Washington Public Power Supply System
A JOINT OPERATING AGENCY

June 1, 1981
GO-1-81-164

Subject: PROJECTS 1 AND 4
DOCKET NOS. 50-460 AND 50-513
REPORTABLE CONDITION 10CFR50.55(e)
COMBUSTION AIR INTAKE DESIGN DEFICIENCY

DIESEL COMBUSTION AIR INTAKES

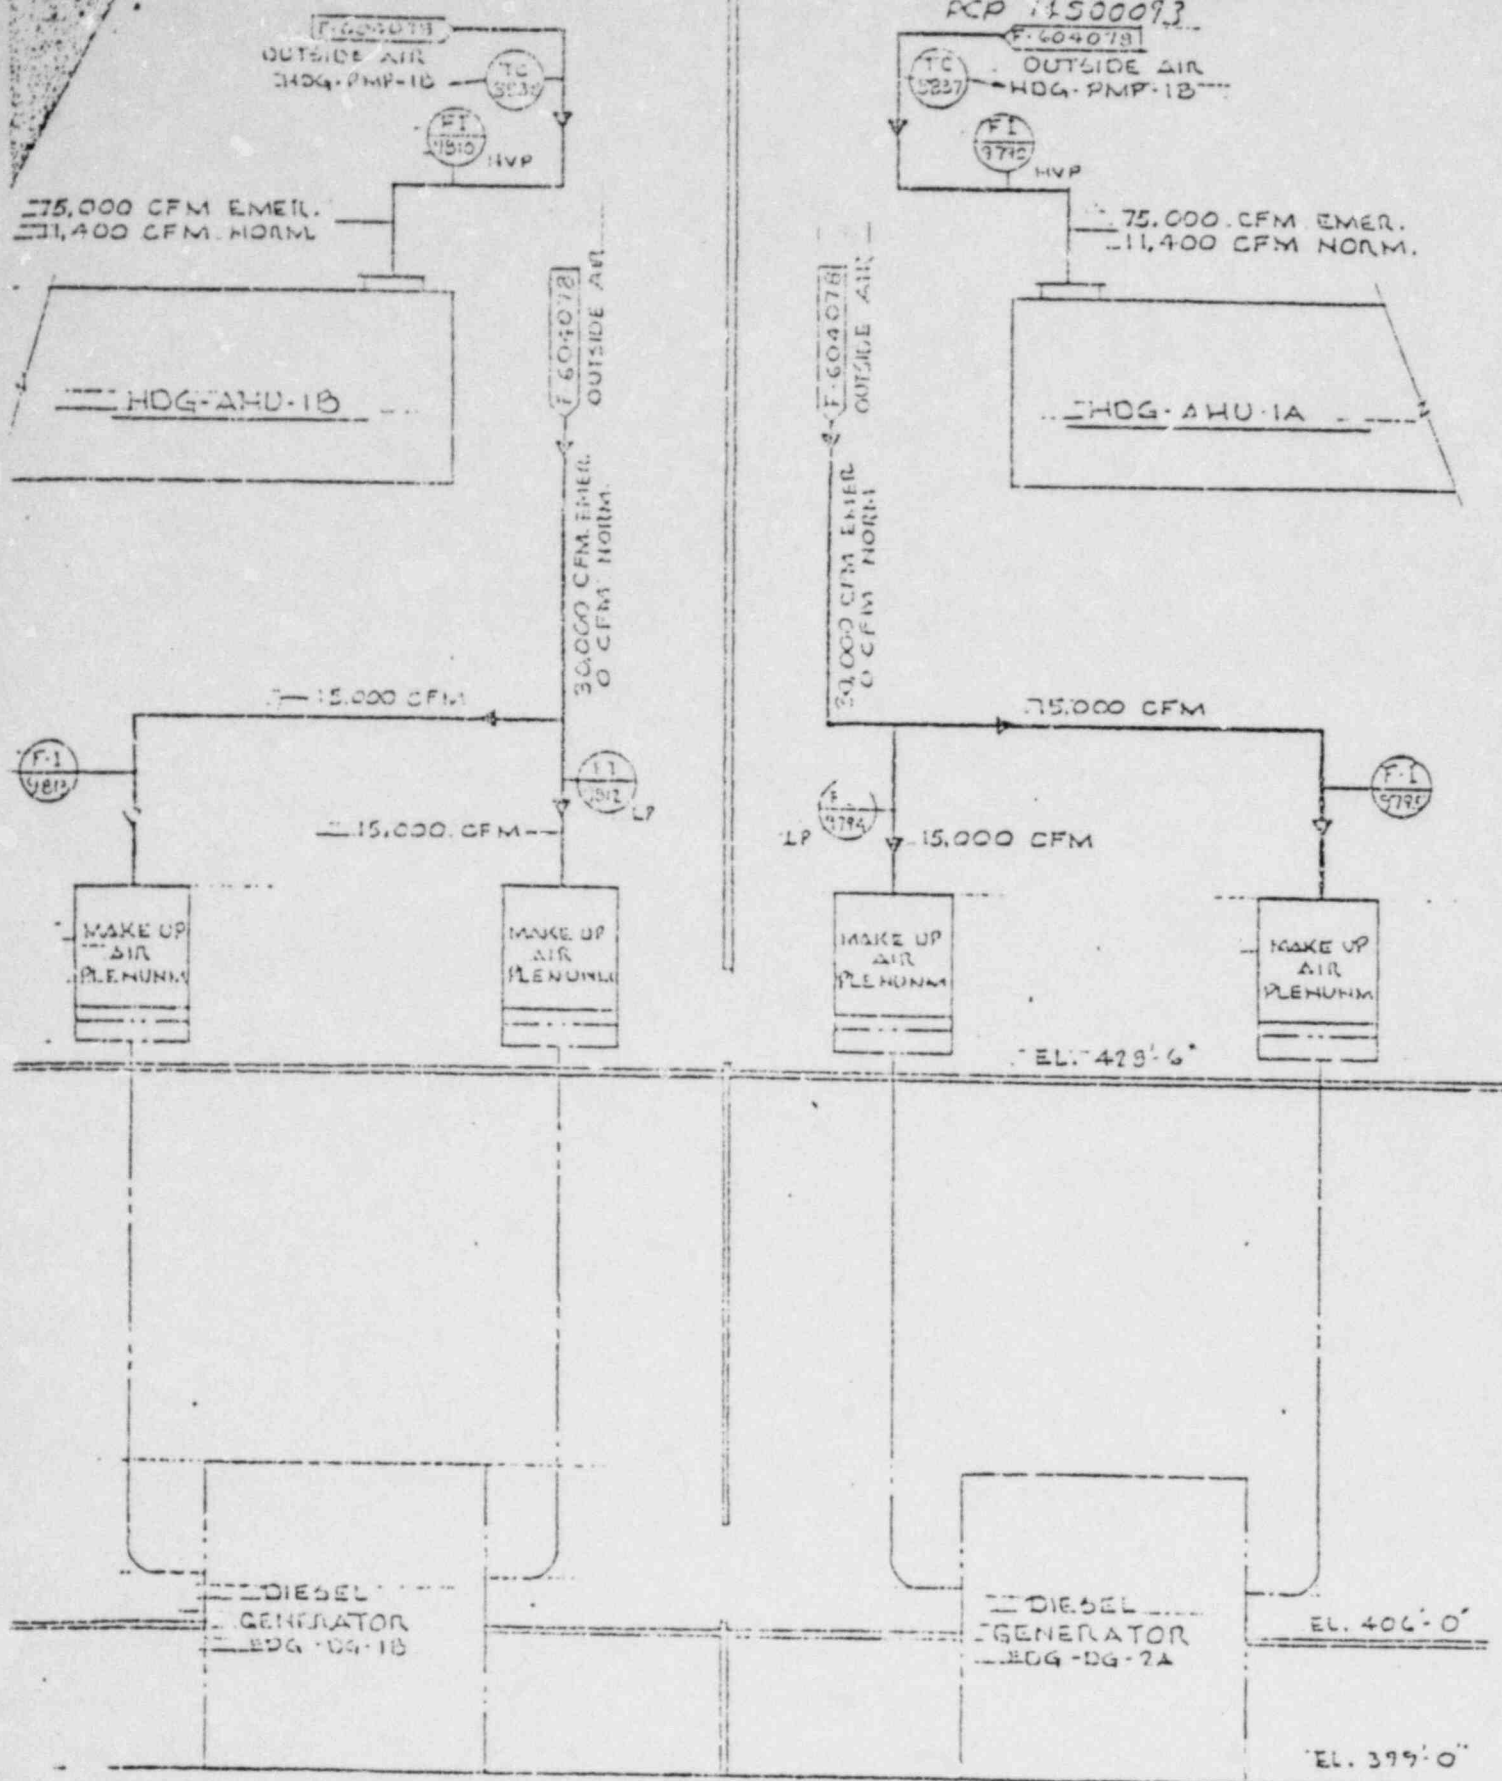
To ensure that the starting of the Diesel Generator (DG), under a tornado condition, would not affect the integrity of the ventilation of other systems, it was proposed that the DG Combustion Air Intakes and HVAC system intakes be separated. Separation of the air intakes from the intake for the HVAC system in the DG area, and placing the DG combustion air intakes ahead of the tornado check valves would ensure safe operation of both systems under tornado conditions.

Proposal was implemented as described. See Attachment II.
